IEEE P802.15
Wireless Personal Area Networks

Project	IEEE P802.15 Working Group for Wireless Personal Area Networks (WPANs)	
Title	Spectral mask for FSK	
Date Submitted	[June, 2010]	
Source	[James P. K. Gilb] [SiBEAM] [555 N. Mathilda, Suite 100, Sunnyvale, CA 94085]	Voice: [408-245-3120] Fax: [408-245-3120] E-mail: [last name at ieee dot org]
Re:	[d1P802-15-4g_Draft_Standard.pdf]	
Abstract	[This document describes changes to add an FSK mask to the draft.]	
Purpose	[To resolve comments in LB51.]	
Notice	This document has been prepared to assist the IEEE P802.15. It is offered as a basis for discussion and is not binding on the contributing individual(s) or organization(s). The material in this document is subject to change in form and content after further study. The contributor(s) reserve(s) the right to add, amend or withdraw material contained herein.	
Release	The contributor acknowledges and accepts that this contribution becomes the property of IEEE and may be made publicly available by P802.15.

2.1 Comment resolution items for FSK/GFSK

Figure 2—2-FSK modulation

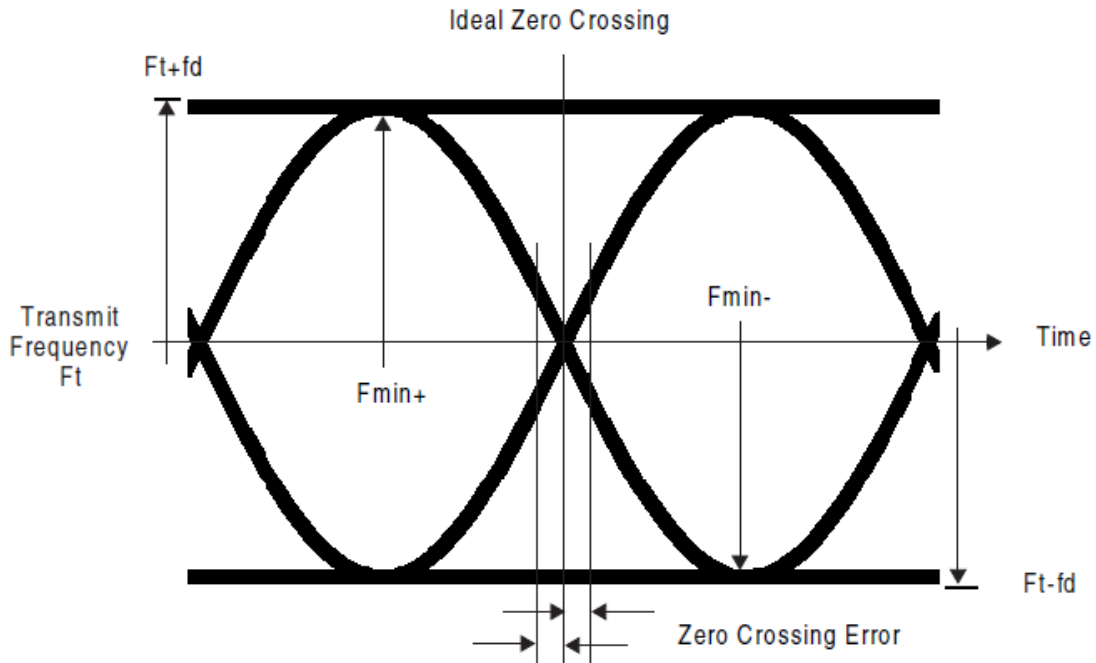
The symbols and terms for 2-FSK signal is illustrated in Figure 2.

For 2-FSK, the error in the modulation, Δf_d , at mid-symbol time shall be less than $\pm 0.2 * \Delta f$, where Δf is defined in 6.12a.1.2.

The zero crossing error shall be less than $\pm 1/8$ of a symbol period.

Figure 3—4-FSK modulation

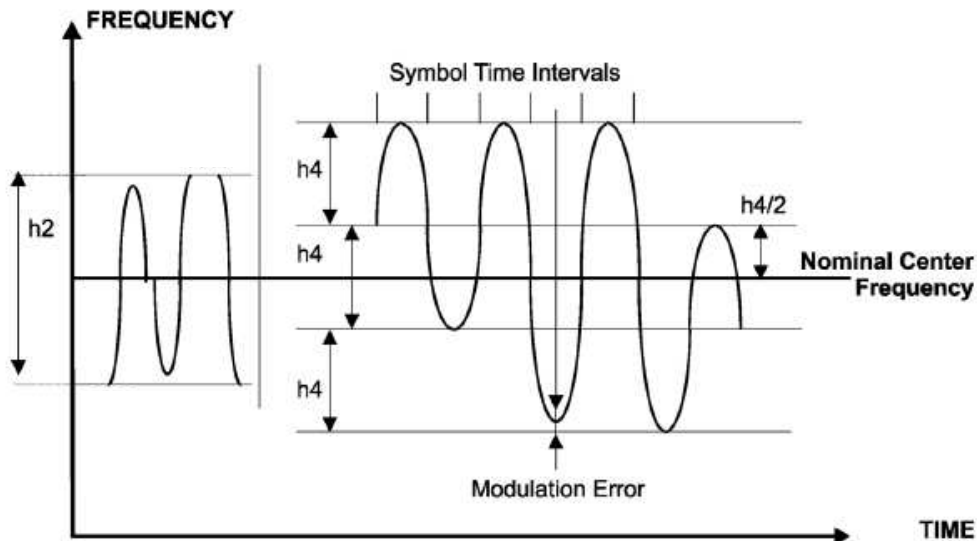
The symbols and terms for 4-FSK are illustrated in Figure 3.

For 4-FSK, the error in the modulation at mid-symbol time shall be less than $\pm 0.2 * \Delta f$, where Δf is defined in 6.12a.1.2.
